Upper's Quarry

MNRF Licence Reference No.	Applicant's Signature
Plan Scale: 1:3000 (Arch E)	Date: October 2021 April 4, 2024
0 90 180 Meters	Drawn By: C.P. File No.: 9811V
File Name	Checked By: D.W.
Drawing No.	Existing Features
1 of 6	
File Path	N:\9811V - Walker Upper's Quarry Drawings\Site Plan\CAD\9811V - Site Plan.dwg

Extraction Sequence

Cross Sections

Key Natural Heritage Features Schematic

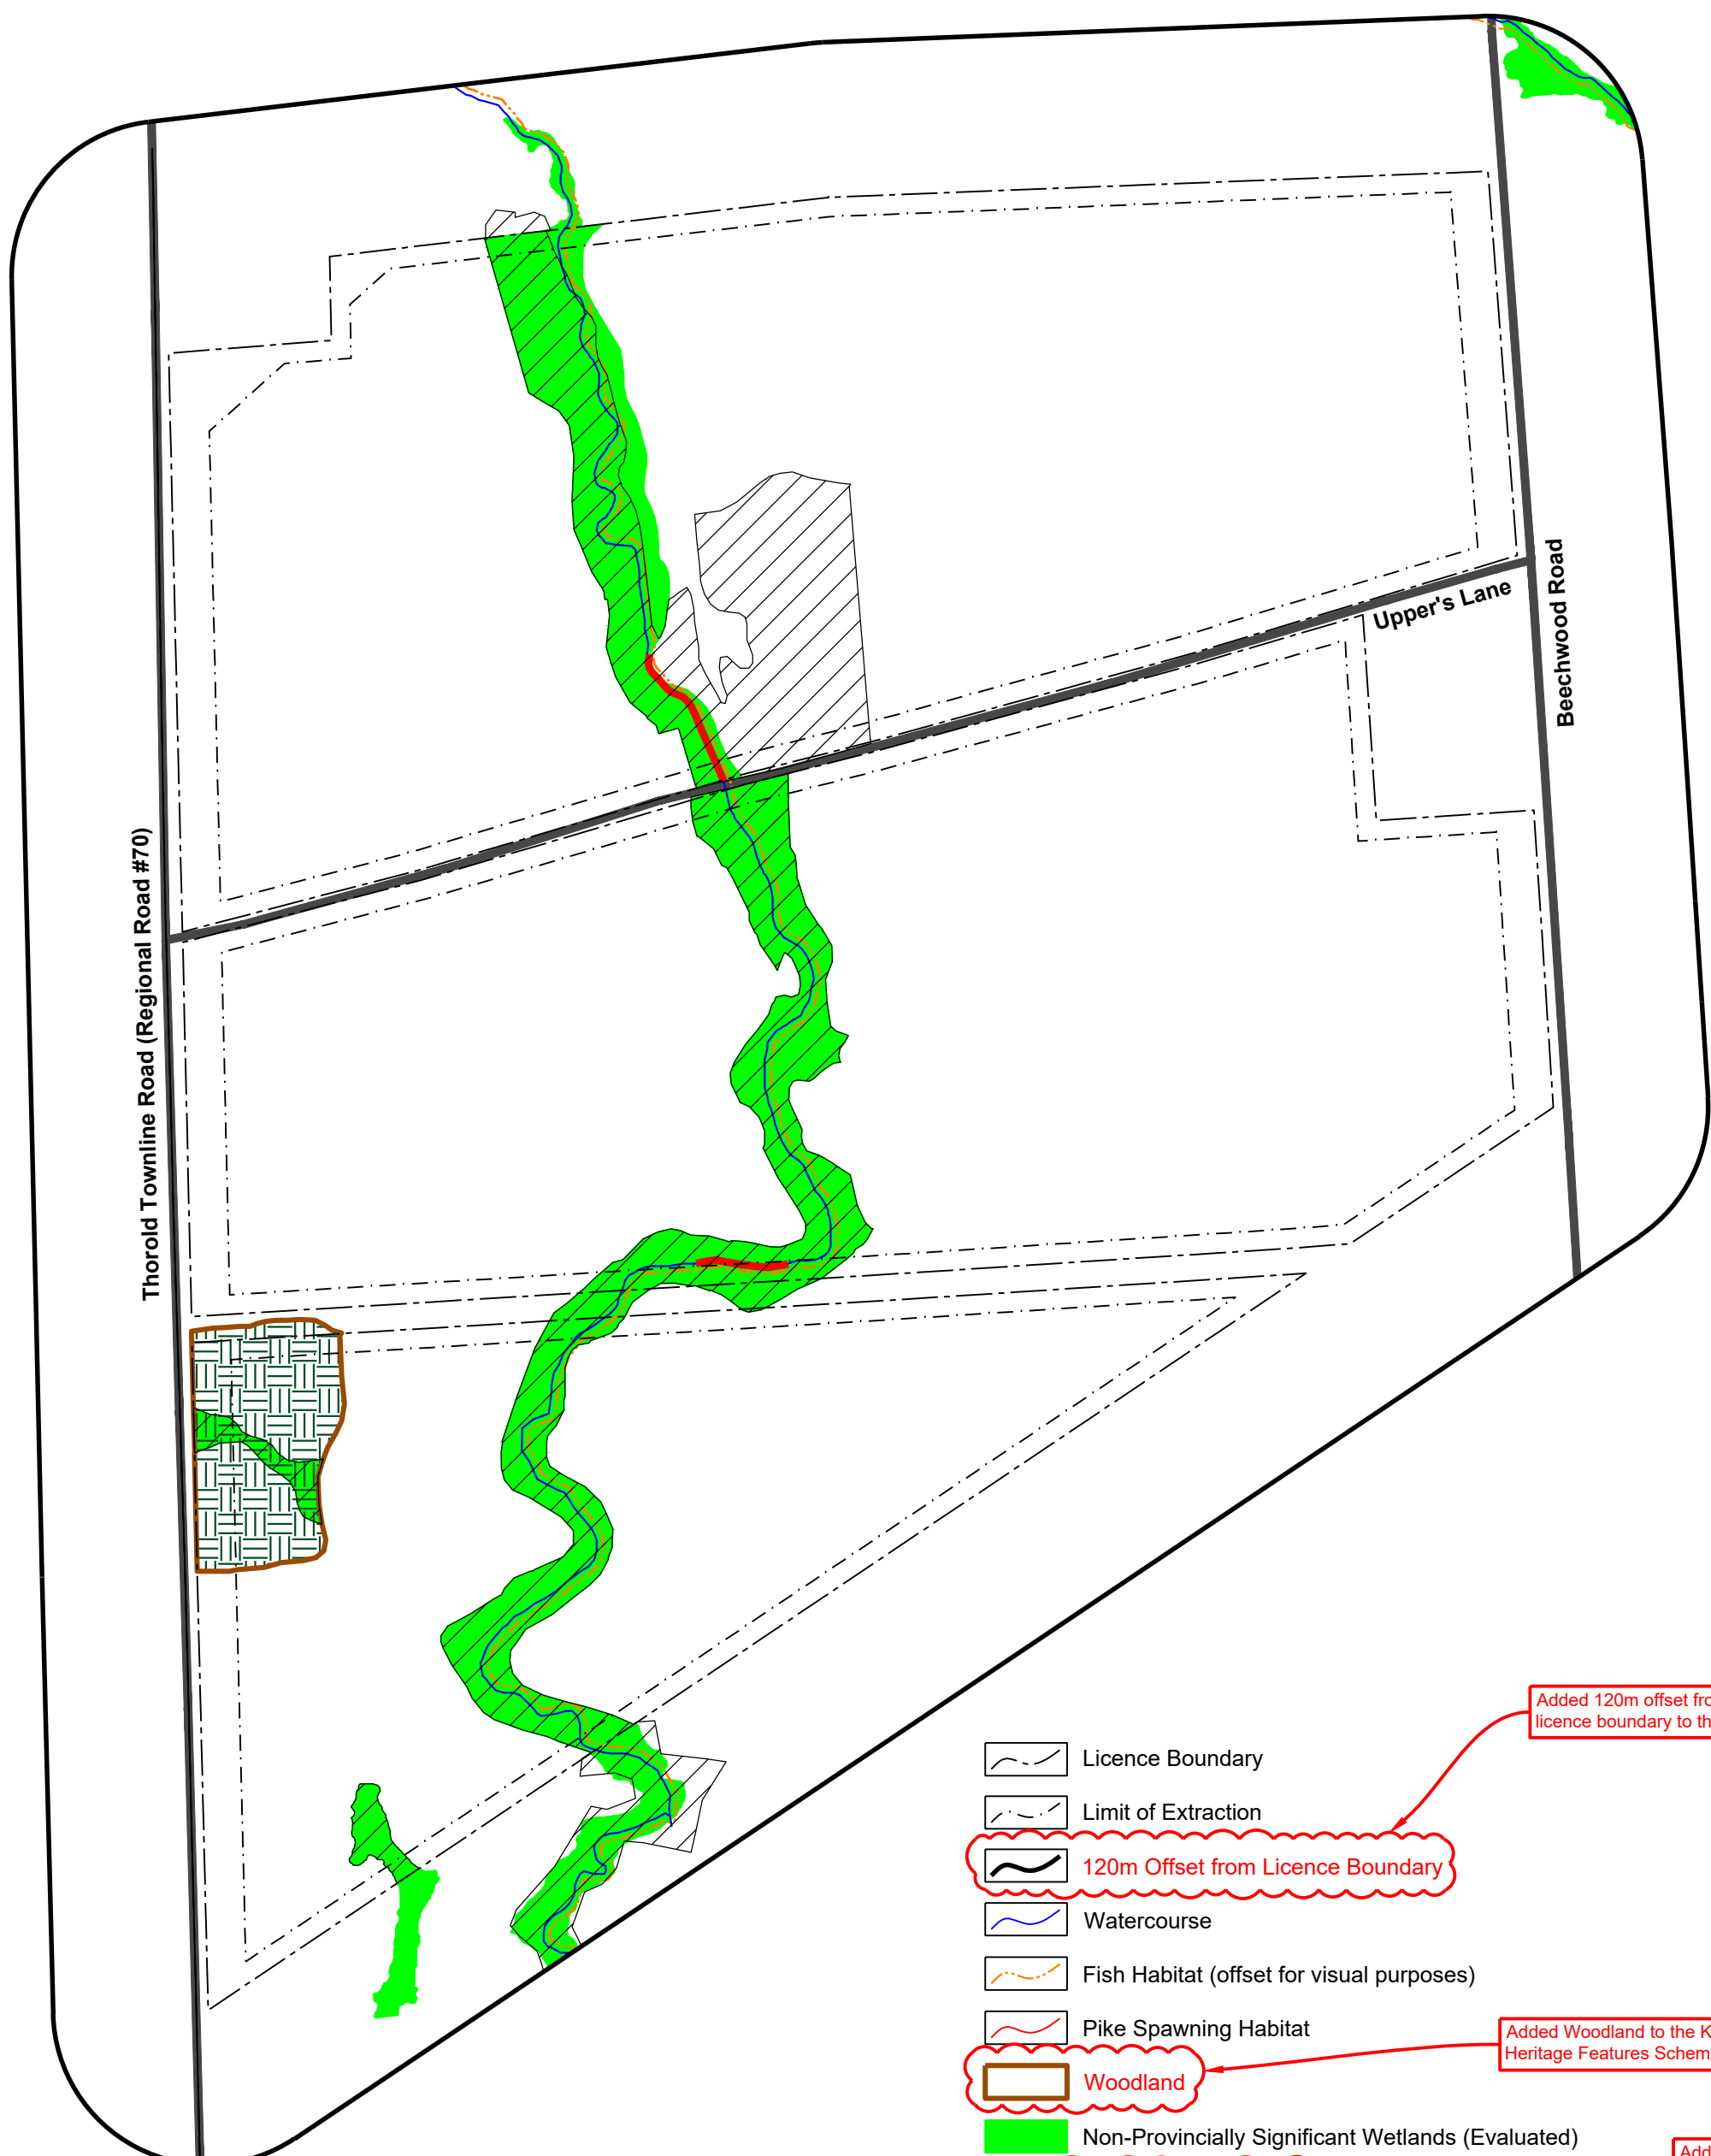
Added 120m offset from the licence boundary to the legend

Added Woodland to the Key Natural Heritage Features Schematic

Added Significant Wildlife Habitat - Mammal to the Key Natural Heritage Features Schematic
